KERRY et al
Appl. No. 10/594,678
April 10, 2008

AMENDMENTS TO THE DRAWINGS

ANNOTATED MARKED UP DRAWINGS
FOR SN 10/594,678

FIGURE 1
(PRIOR ART)

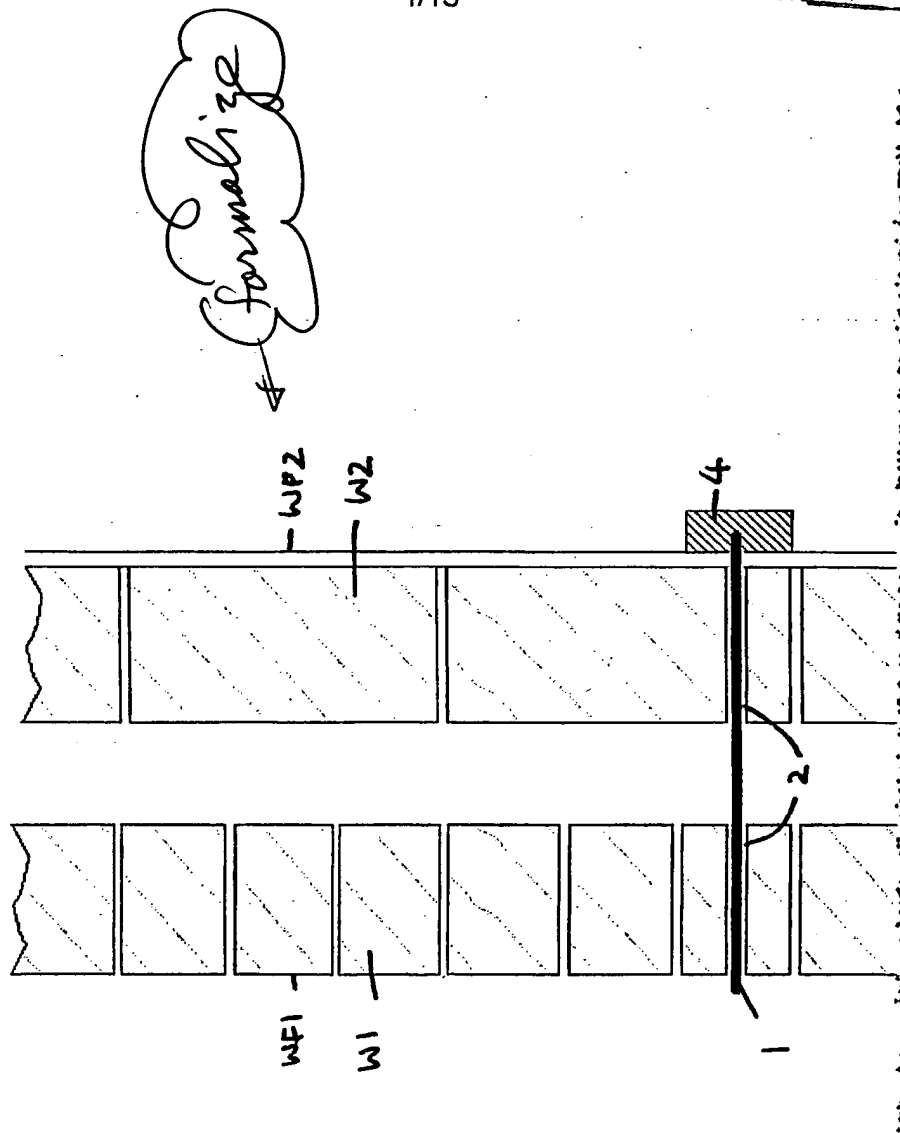
The drawings have been amended to add the "Prior Art" legend to Figures 1-2 as requested. In addition, the drawings have been otherwise "formalized".

FIGURE 2 A
(PRIOR ART)

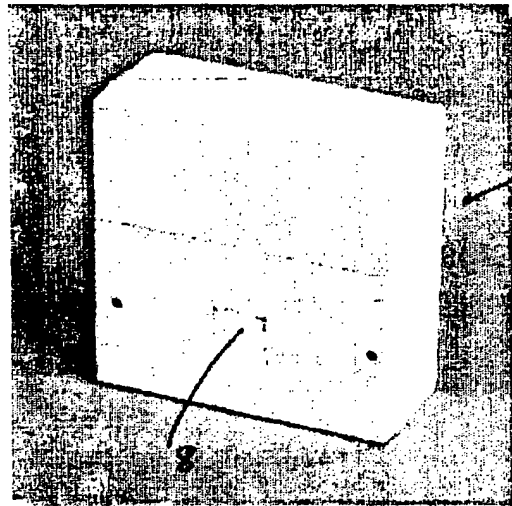
clean up

formalize

FIGURE 3

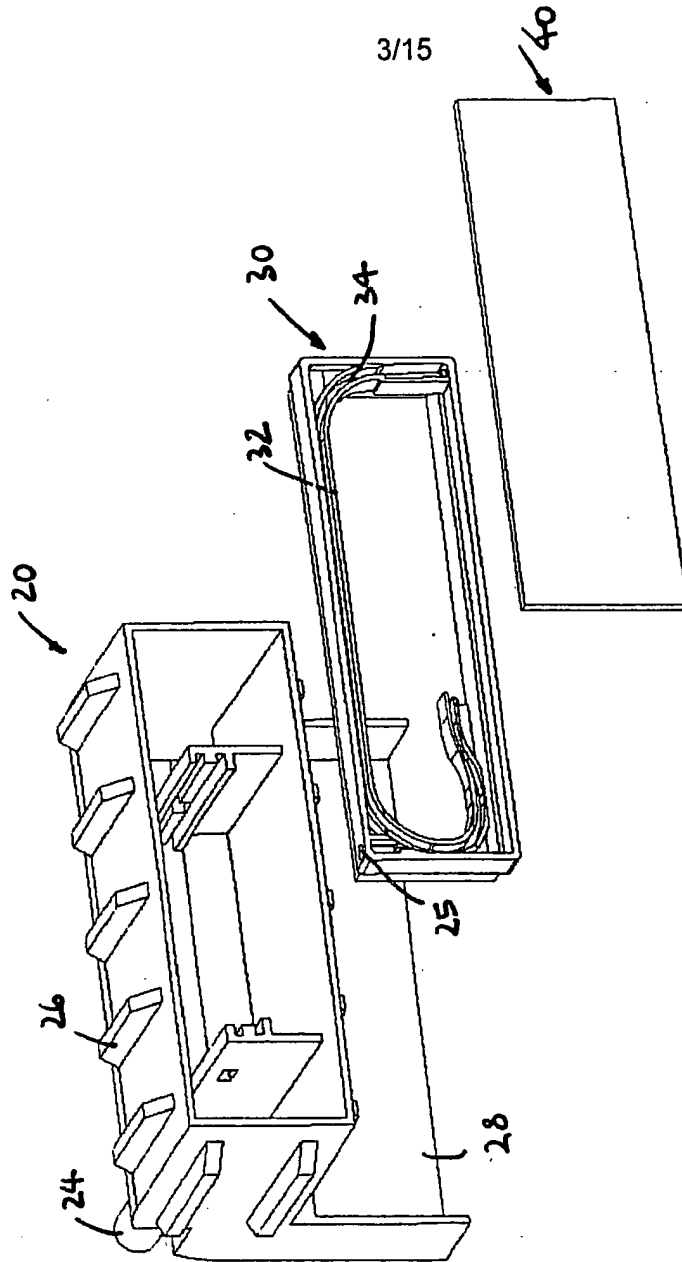
Formalize

FIGURE 5A

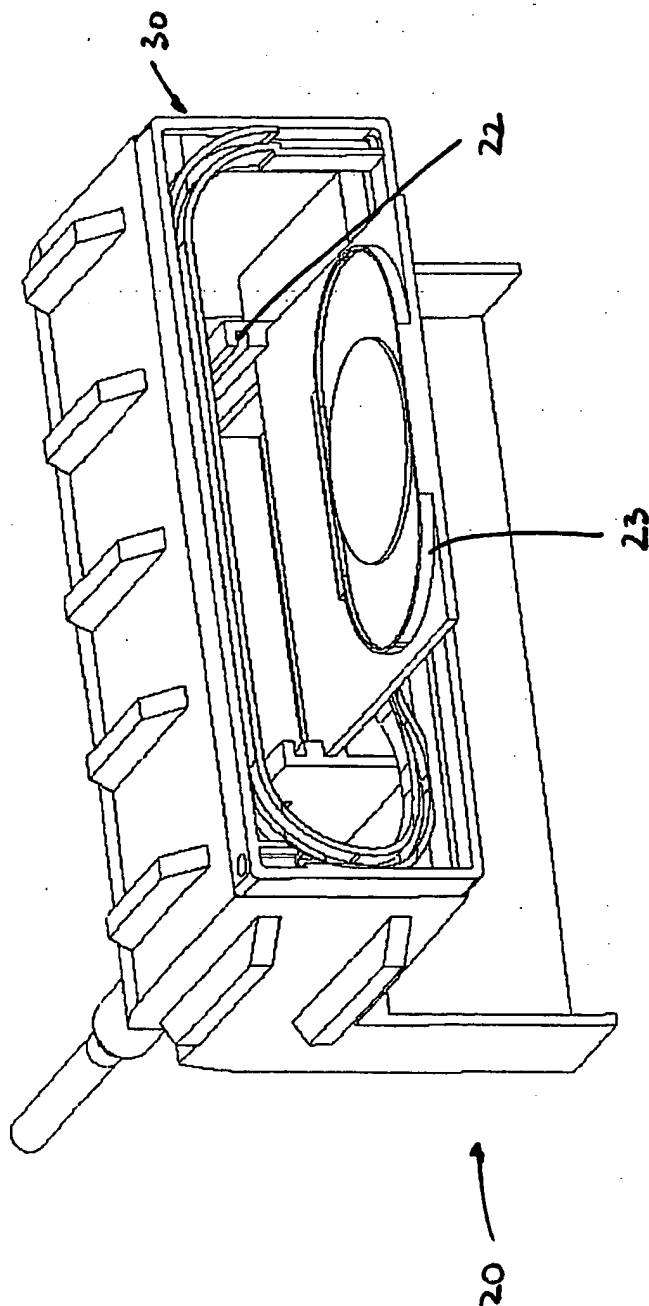
formalize

FIGURE 5B

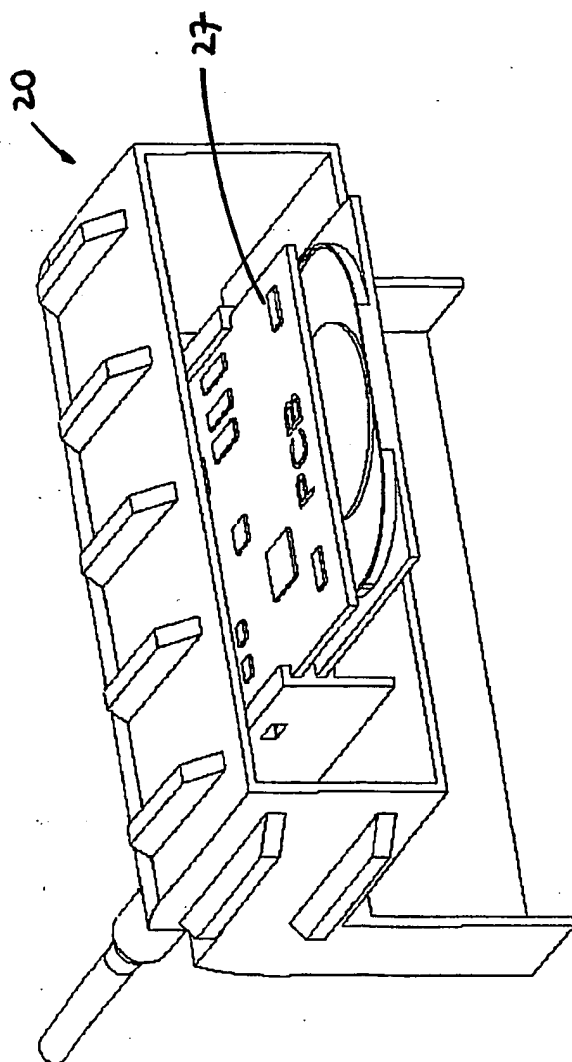
Formalize

FIGURE 7A

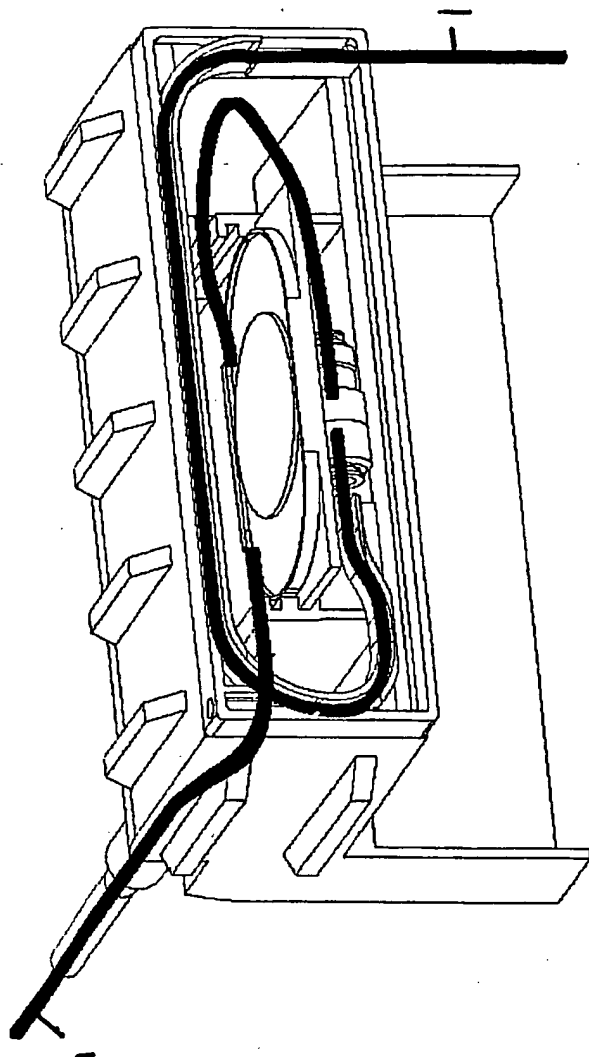
formalize

FIGURE 7B

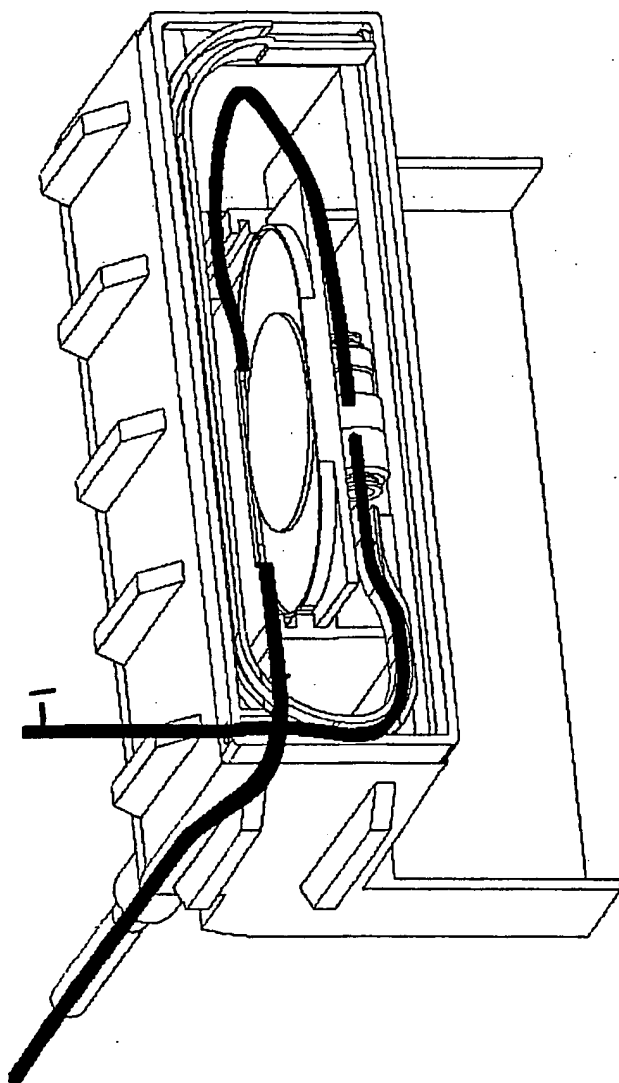
formalize

FIGURE 8

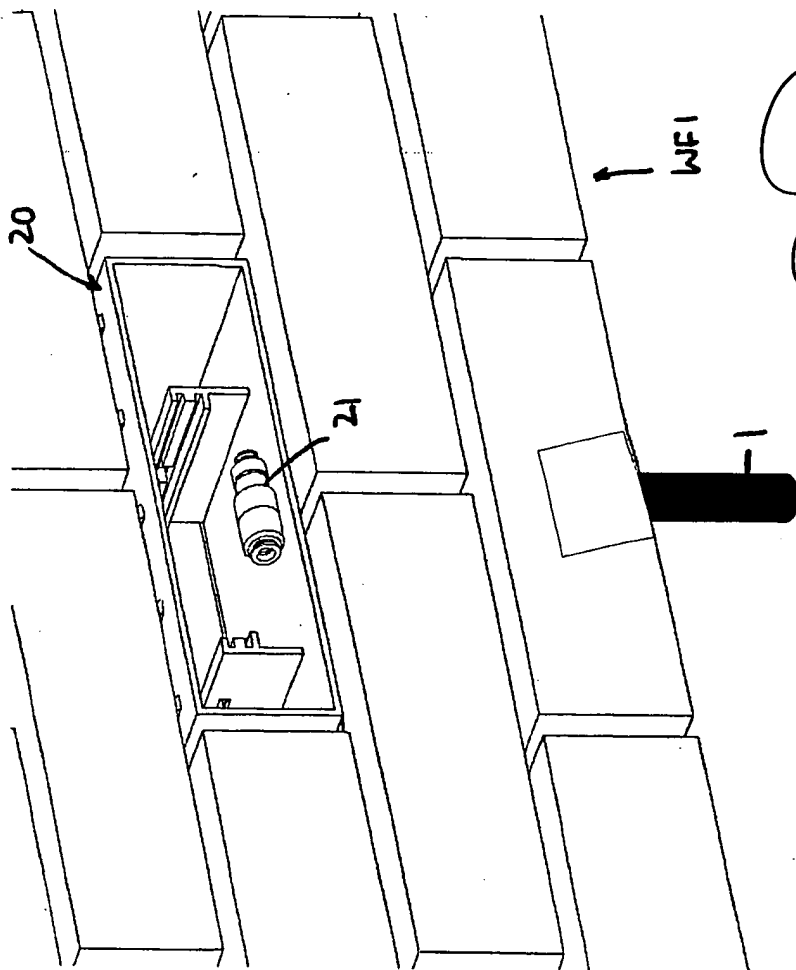
Formalize

FIGURE 9

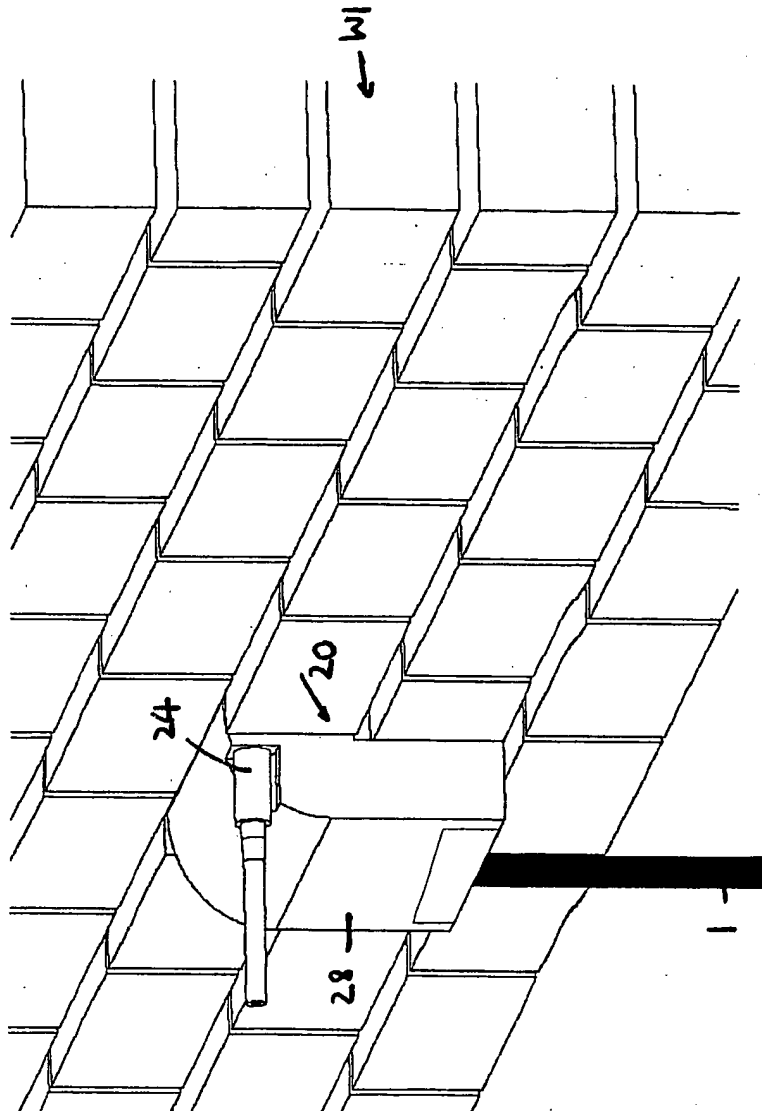
formalize

FIGURE 10B

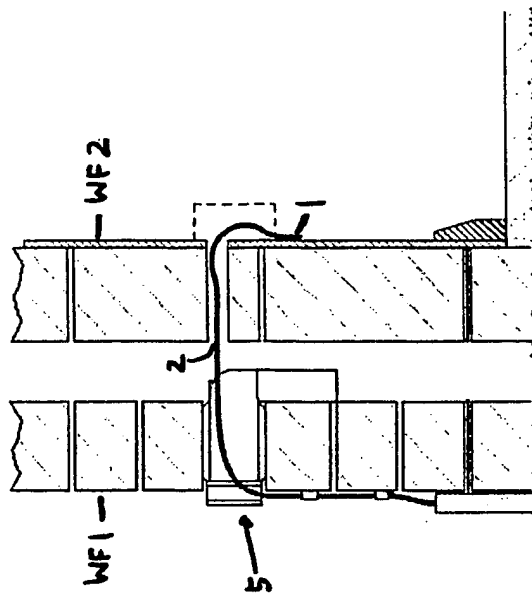
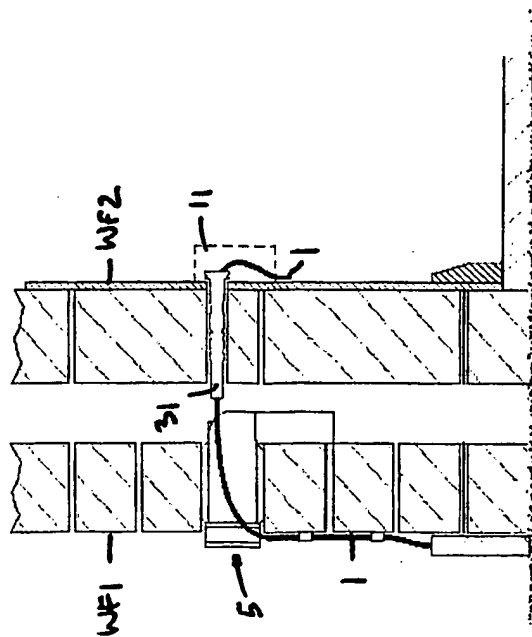
formalize

FIGURE 11B

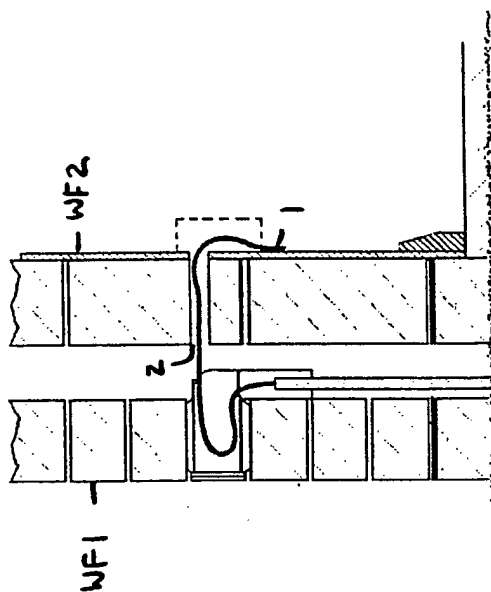
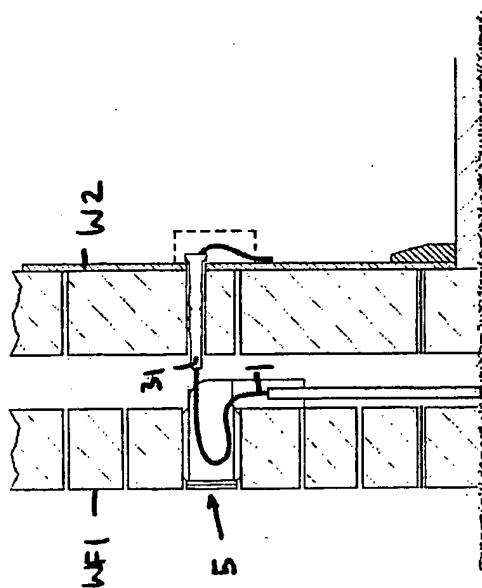
formalize

FIGURE 12

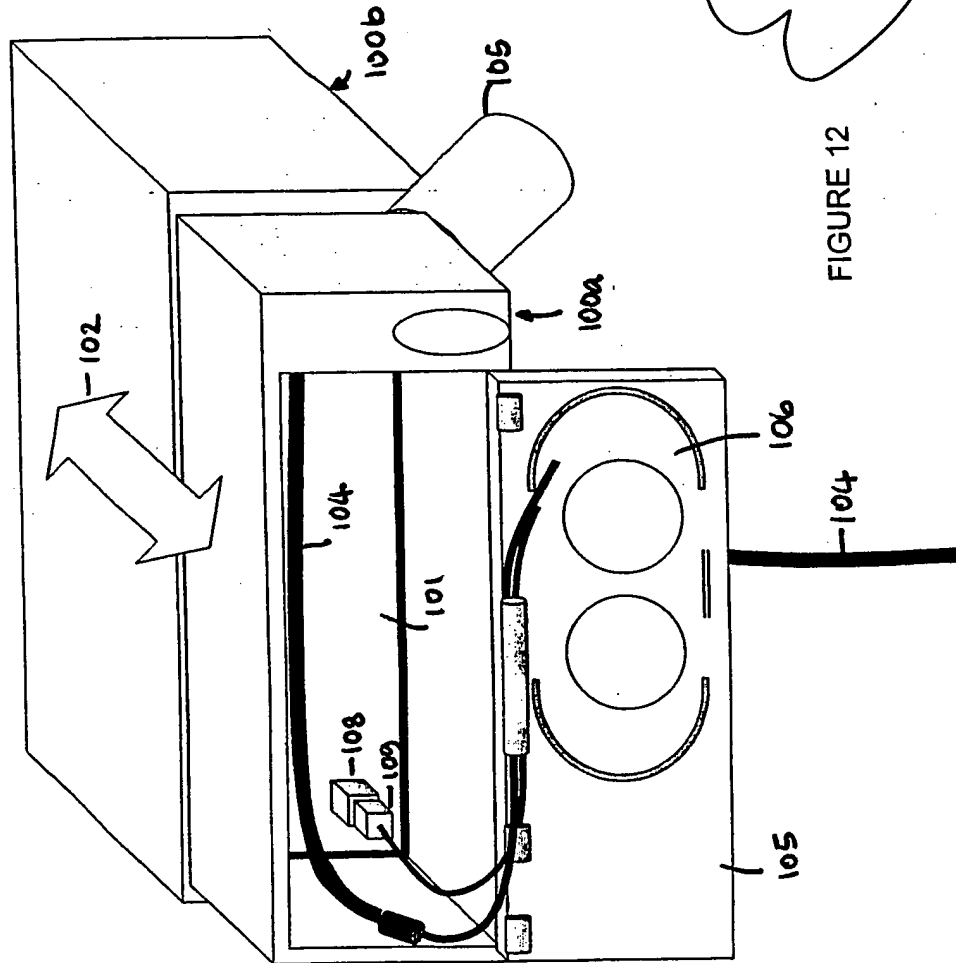
Formalize
